<b>AMENDMENT OF SOLICITATION/MODIFICATION OF CONTRACT</b>			1. CONTRACT ID CODE	PAGE OF PAGES 1   21
2. AMENDMENT/MODIFICATION NO. 0001	3. EFFECTIVE DATE 08/20/93	4. REQUISITION/PURCHASE REQ. NO. ED0000-3117-0034	5. PROJECT NO. (If applicable) dk	
6. ISSUED BY US ARMY ENGR DIST NEW ORLEANS PO BOX 60267 NEW ORLEANS LA 70160-0267  Molly M. Block	CODE ISSUE1	7. ADMINISTERED BY (If other than Item 6) US ARMY ENGR DIST, NEW ORLEANS ATTN CELMN-CT PO BOX 60267 NEW ORLEANS LA 70160-0267		
		CODE	ADMIN1	
		SC2 (504)862-2879

14. DESCRIPTION OF AMENDMENT/MODIFICATION (Organized by UCF section headings, including solicitation/contract subject matter where feasible.)

Plans and Specifications covering Lake Pontchartrain, La. and Vicinity, High Level Plan, London Ave. Outfall Canal Parallel Protection, Pumping Station No. 3 to Mirabeau Ave. Floodwall, Orleans Parish, La., are hereby amended as follows:

GUYING DETAILS FOR RELOCATED TREES

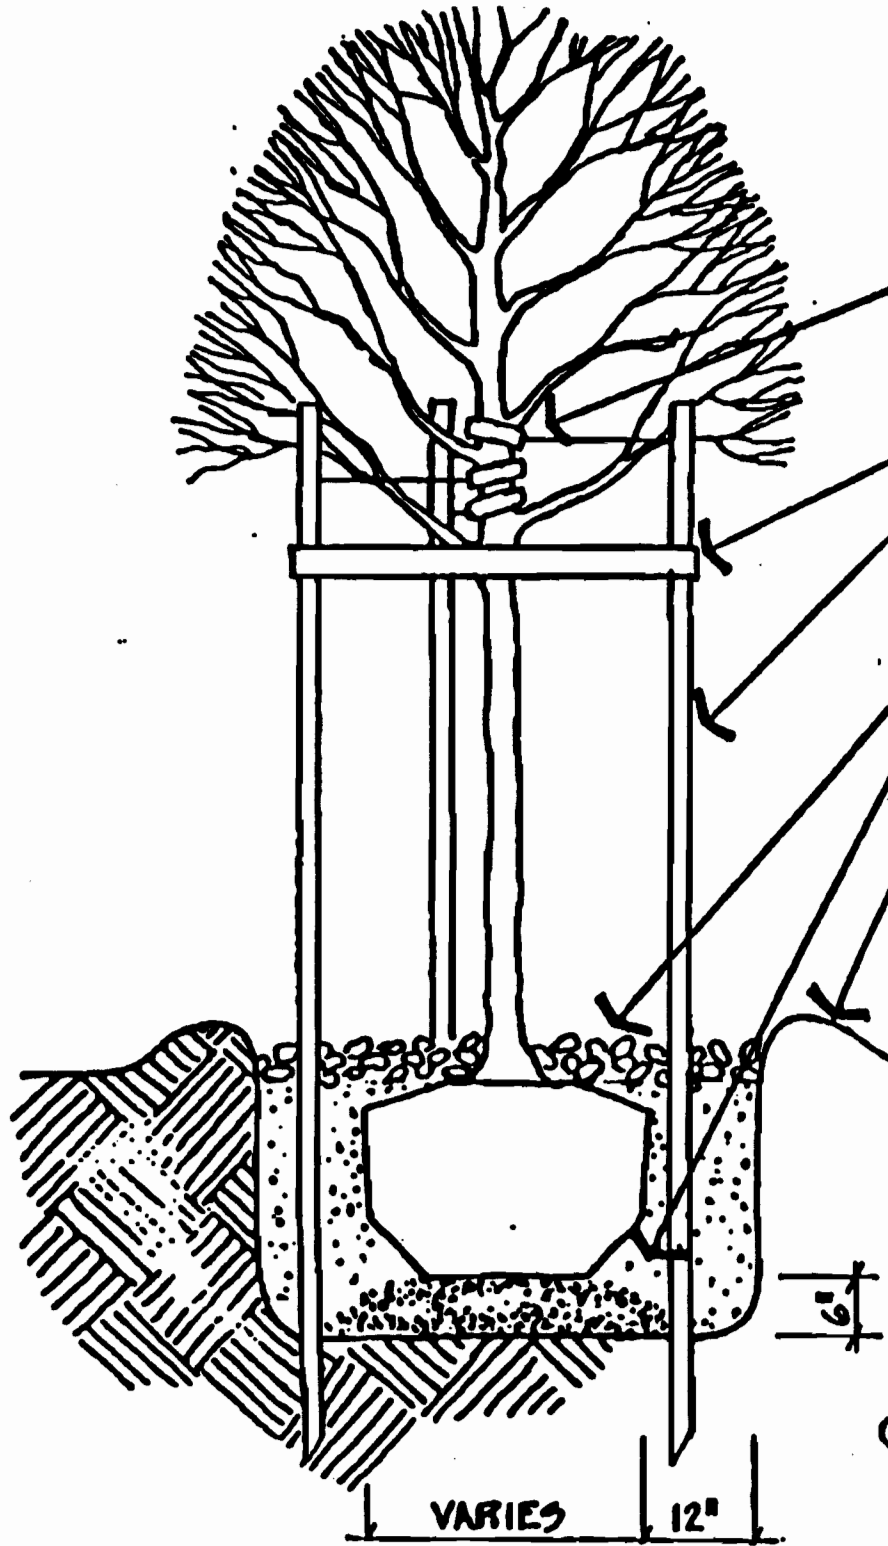
**C2M-8.5 Guying.** Immediately after planting, the trees shall be supported by guying and staking as shown in details at the end of this section.
